Report to Planning Committee 6 July 2023

Report Summary			
Application Number	22/01298/FUL		
Proposal	Proposed retail unit with parking and amended site entrances		
Location	Tesco Express, Kirklington Road, Rainworth, NG21 0AE		
Applicant	Mr K Nijjar	Agent	Alan McGowan Architects - Mr Alan McGowan
Registered	30 June 2022	Target Date	25 August 2022
		Extension of Time	14 July 2023
Web link	22/01298/FUL Proposed retail unit with parking and amended site entrances Tesco Express Kirklington Road Rainworth Nottinghamshire NG21 0AE		
Recommendation	That planning permission is APPROVED subject to the conditions outlined at the end of this report

Kirklington Road pedestrian central refuge

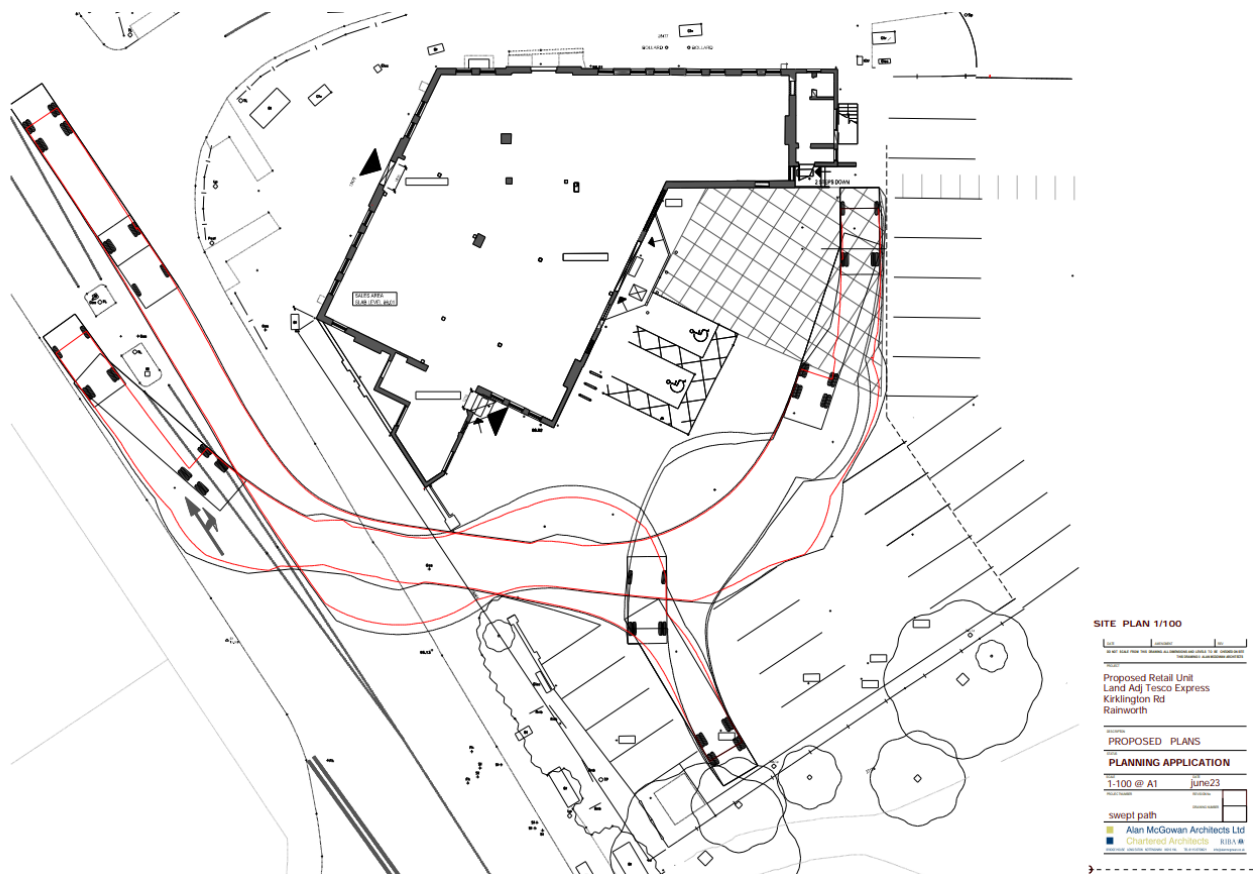
Highways - Pedestrian central refuge on Kirklington Road near the access is now shown on all the newly submitted plans. This refuge is to remain as existing and, for clarification, it is not proposed to be removed.

Despite being consulted on revisions, Rainworth Parish Council still believe the pedestrian central refuge will be removed to facilitate access, however, this is not the case, and the scheme has been amended accordingly to clarify. Before the scheme was amended to enable the existing and proposed retail units to share the Southwell Road East access for deliveries, the Highway Authority was concerned that delivery lorries would cut across part of the pedestrian central refuge when turning right out of the Kirklington Road access (see comments regarding swept path analysis below). To confirm, it was never proposed to remove this element of the highway, which is out of the applicant's control.
